Stellaris® LM3S9B96 RevB1 Errata

This document contains errata as of October 2013 for the Stellaris LM3S9B96 microcontroller. Additional errata added after October 2013 that apply to revision B1 can be found in the *Stellaris® LM3S Tempest- and Firestorm-Class Microcontrollers Errata* ([SPMZ861](#)). Read both documents for the complete list of errata for your device.

Figure 1. VDD Waveform Signature Limits

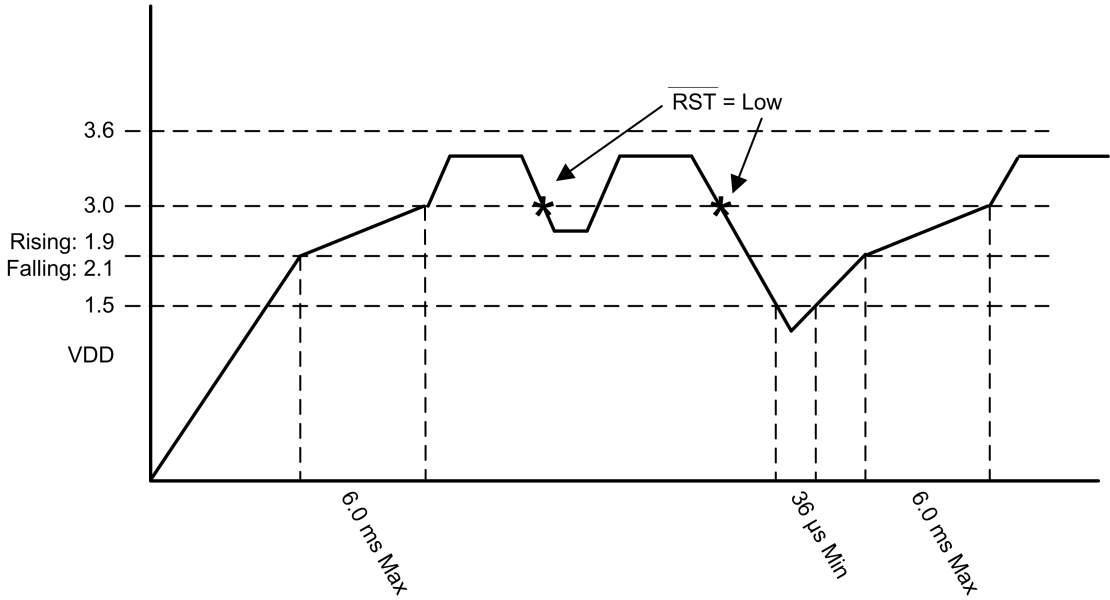
The Power-On Reset gap occurs because the supervisor can release internal state machine operation as soon as 6.0 ms after the VDD supply reaches 1.9 V. If VDD is still below the minimum operating voltage of 3.0 V after 6.0 ms, the power-up state machine may not function correctly, resulting in the effects described above. The $\overline{\text{RST}}$ pin of the device has no effect on the initialization state machine, therefore, a complete power-cycle is required to restore the initialization state machine.

The Brown-Out Reset threshold (V_{BTH}) gap occurs because the brown-out supervisor has a threshold as low as 2.85 V, which is less than the minimum operating voltage on VDD, and also because it can take several microseconds to respond. BOR gaps can be encountered after power up, during steady state operation power-on, if the VDD rail has glitches, and also during power-down.

After initial power-up, any processor operation with VDD below 3.0 V may result in unexpected code execution resulting in the effects described above. The processor must be halted or the $\overline{\text{RST}}$ signal must be driven Low prior to VDD dropping below 3.0 V and stay in that state until VDD is above 3.0 V.

If VDD falls below 2.1 V, it must continue to fall until it reaches 1.5 V. VDD must stay below 1.5 V for at least 36 μs to ensure that a POR is triggered correctly. Additionally, the VDD power-up time between 1.9 V and 3.0 V must be at most 6.0 ms. If VDD falls below 3.0 V but stays above 2.1 V, it is not necessary for the voltage to continue falling below 2.1 V. VDD can come back up to 3.0 V without any additional timing requirements.

1. The VDD power-up, steady state, and power-down waveform meets the timing requirements shown in Figure 1 on page 14.
2. The power-up transition of VDD between 1.9 V and 3.0 V must not have any points where it decreases in voltage (must be monotonic).
3. The power-down transition of VDD between 3.0 V and 1.5 V must not have any points where it increases in voltage (must be monotonic).
4. Once steady-state operation between 3.0 V and 3.6 V is achieved, $\overline{\text{RST}}$ must go Low or the CPU execution must be halted prior to VDD falling below 3.0 V.
5. The **Brown-Out Reset Control (PBORCTL)** register must be set so that a brown-out event causes a reset.

Figure 2. Using a Voltage Supervisor to Monitor the Voltage Rail

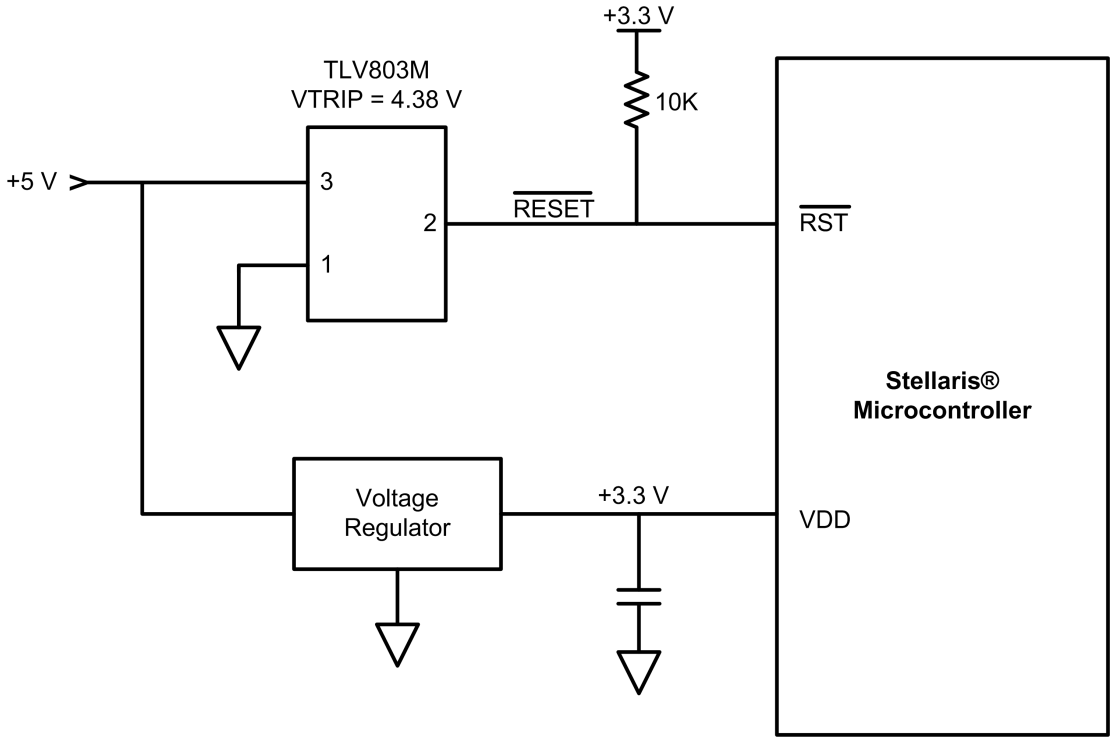
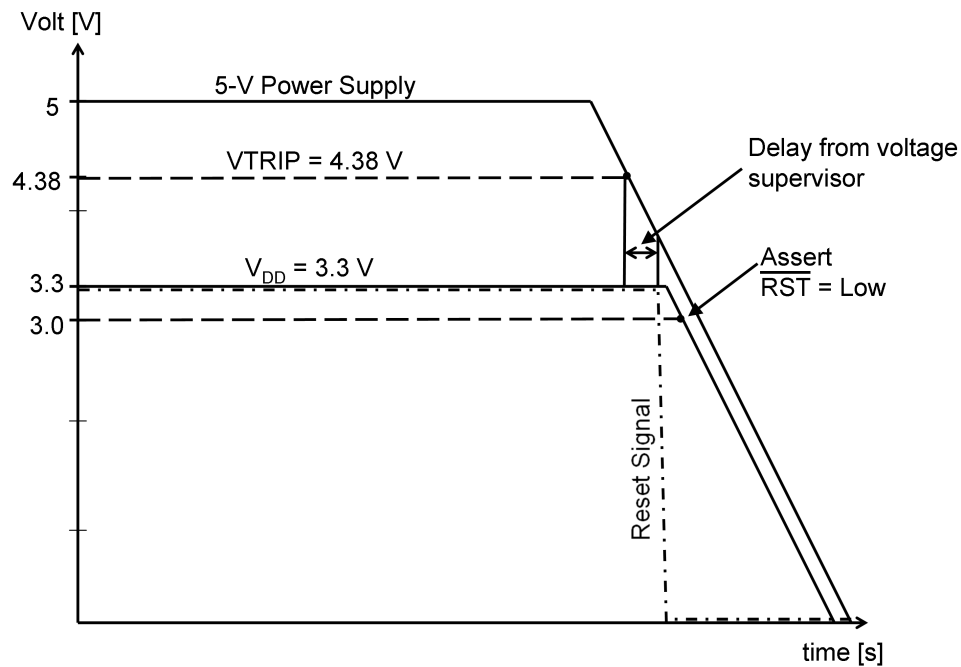
Depending on the system environment requirement, items 3, 4, and 5 in the above list may be met by using a voltage supervisor, such as the TLV803M, to monitor a higher voltage rail from which the VDD supply is regulated. Figure 2 on page 14 shows this implementation with a voltage supervisor monitoring the 5-V rail and a voltage trip point of 4.38 V. A voltage supervisor with a lower voltage trip point can be used to monitor the VDD (3.3-V) rail, however this supervisor must assert reset before VDD reaches 3.0 V. Regardless of the implemented voltage supervisor circuit, the system designer must ensure that there is enough time to assert $\overline{\text{RST}}$ Low prior to VDD falling below 3.0 V. Figure 3 on page 15 shows the resulting waveform of the circuit shown in Figure 2 on page 14.

Figure 4. Chip Selects**Silicon Revision Affected:**

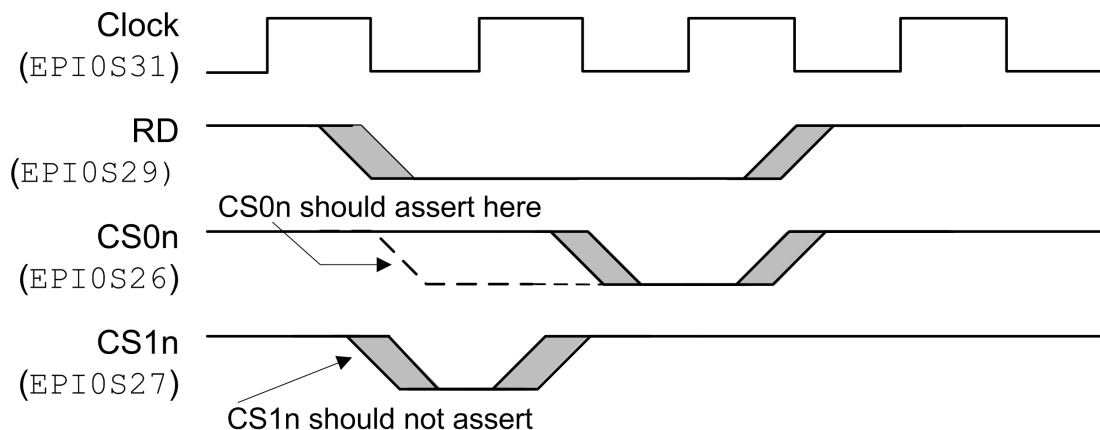
Chip select operation for the first read is not correct when the EPI module is in Host Bus mode and is configured to use dual chip selects (the `CSCFG` field in the **EPIHBnCFG2** register is 0x2) and Continuous Read mode (the `MODE` field in the **EPIHBnCFG** register is 0x2). When accessing a memory region assigned to one chip select, the other chip select is asserted first along with the RD strobe. This incorrect chip select is de-asserted before the next EPI clock edge and the correct chip select is asserted on that EPI clock edge. The RD strobe remains asserted, but the number of cycles that it is asserted includes the time that it is asserted with the incorrect chip select.

For example, if the RD strobe is programmed to be asserted for two clocks (the `RDWS` field in the **EPIHBnCFG** register is 0x0), the signal is asserted for one clock cycle with the incorrect chip select and one clock cycle with the correct chip select. As long as the width of the RD strobe is adjusted for this one clock difference, data is read correctly in this mode. Figure 4 on page 16 shows the read and chip select timing of this example when accessing a memory region assigned to CS0n.

Use a value in the `RDWS` field in the `EPIHBnCFG` register that is 1 more than required for the peripheral in the system.

For example, if the peripheral requires a read strobe that is 4 EPI clocks wide, set the `MODE` field to be 0x2 (6 clocks) to account for the 1 clock difference in the strobe width.

Figure 5. Timing Differences Between Rev B and Rev C Devices

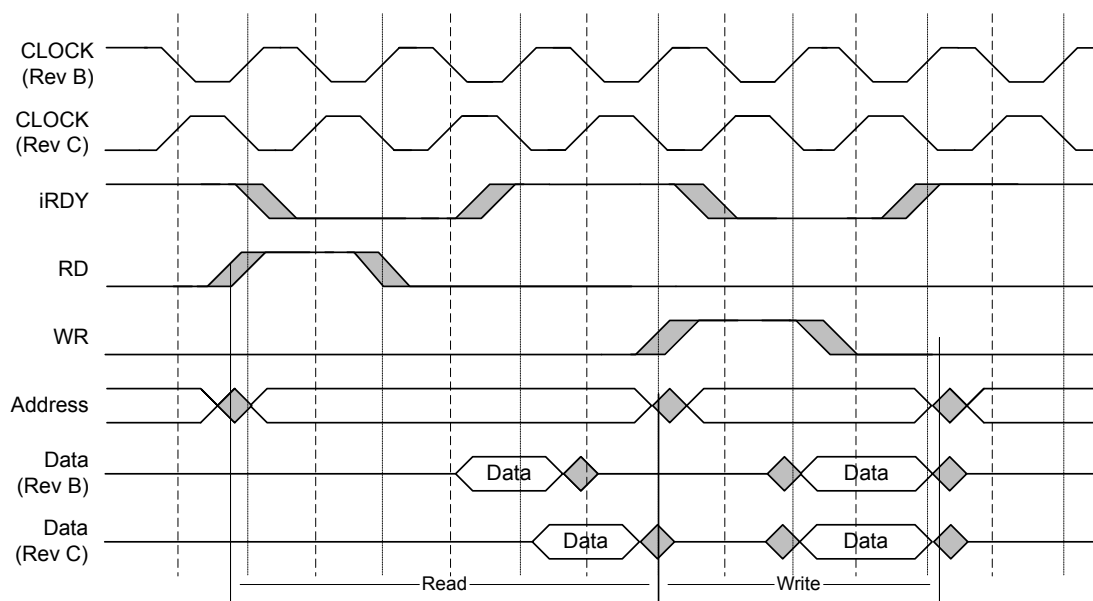
The clock signal that is output on the EPI0S31 signal in General-Purpose mode is inverted. Figure 5 on page 24 shows the timing differences between Rev B parts and Rev C parts.

Figure 6. iRDY Timing**Silicon Revision Affected:**

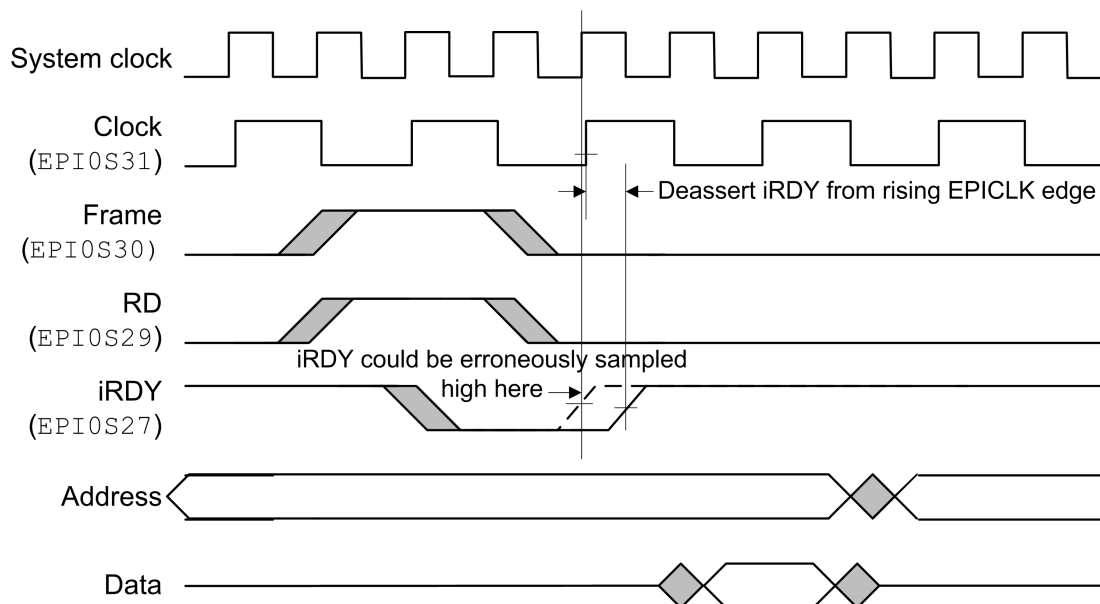
The data sheet specifies that ready input (iRDY) is sampled on the falling edge of the EPI clock, when it is actually sampled on the rising edge of system clock when configured for General-Purpose mode. The iRDY signal may be seen earlier than expected.

For example, if the system clock frequency is configured for 80 MHz (12.5 ns period) and the EPI clock frequency is configured for 40 MHz (25 ns period), there is a 2.5 ns window $((25 \text{ ns} - 12.5 \text{ ns}) - 10 \text{ ns})$, where 10 ns is the iRDY assertion or deassertion set up time (TRDYSU) where the iRDY signal may be asserted. Figure 6 on page 28 shows where iRDY is actually sampled when trying to stall the data phase. iRDY should be deasserted after the next falling edge of EPICLK. iRDY could be erroneously sampled high if it is deasserted at the dotted line.

Figure 7. Recommended Center-Tap Connections

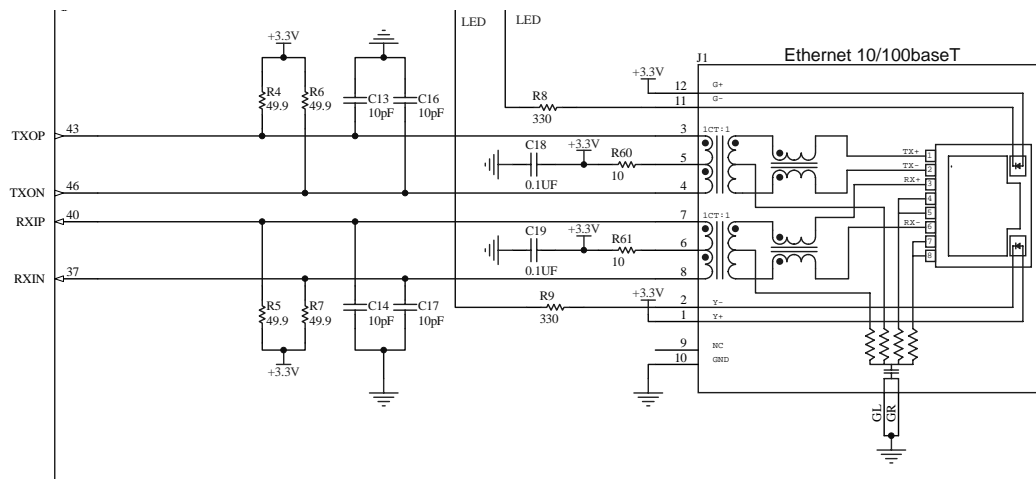
The microcontroller experiences some packet loss with Ethernet cables longer than 50 meters in normal operating conditions.

1. Add 10 Ω resistor to the center-tap of the transformer as shown in the figure. These resistors should be replaced by a direct connection for silicon that has this item fixed.
2. Continue using the recommended circuit, but limit cable lengths to 50 meters.

Figure 8. Example of USB Certification Failure

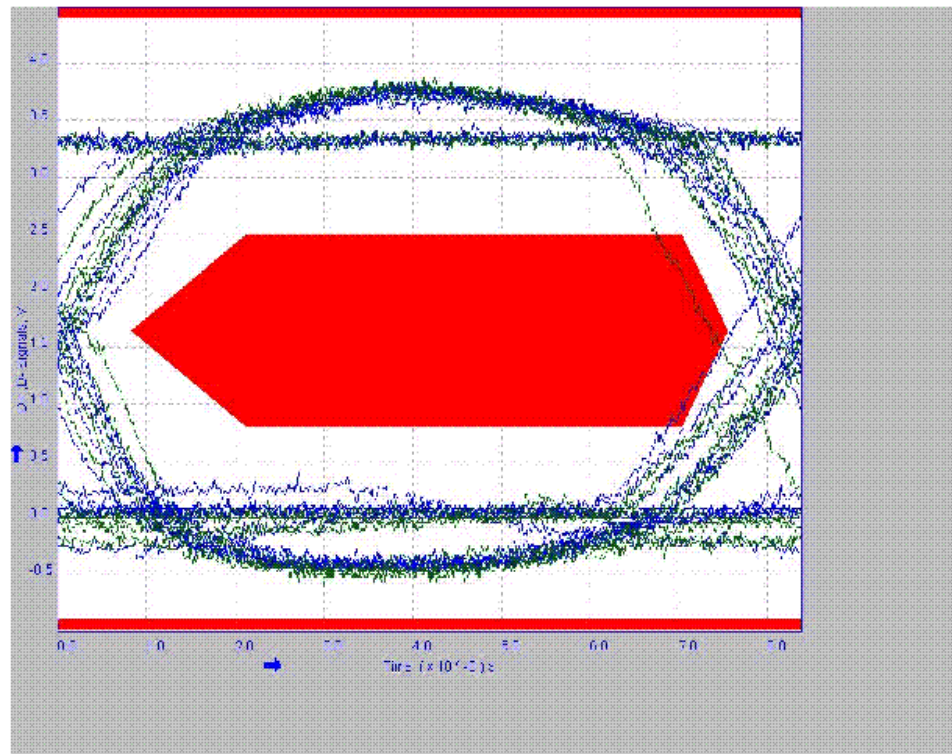
If the EPI module is operating, the USB interface may fail USB certification. Failures have been seen for the eye diagram and jitter (see Figure 8 on page 47). Because of these issues, there is a potential for data corruption on the USB interface when using the USB and EPI at the same time. The risk of data corruption is small, but is dependent on the system design.

Figure 13. Configuration of External Regulator

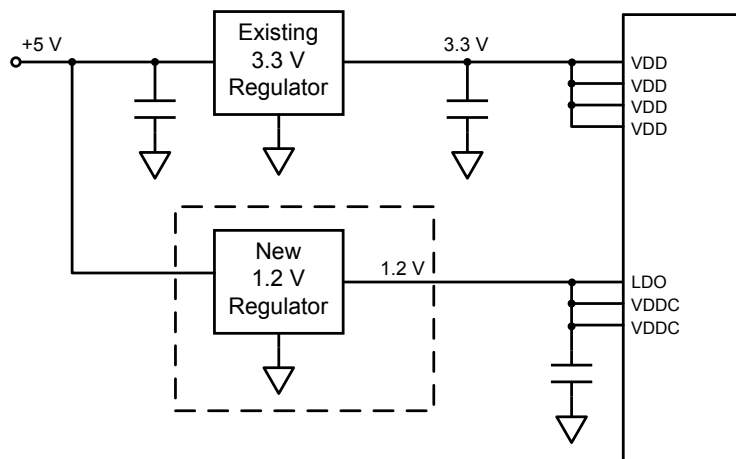
V_{DDC} must be applied approximately 50 μs before V_{DD} . Normally V_{DDC} is controlled by the part's internal LDO voltage regulator. The workaround requires the addition of an external regulator (see Figure 13) to ensure that V_{DDC} sequencing requirements are met (see Figure 14). A recommended regulator is the TI TPS73101DBVR.
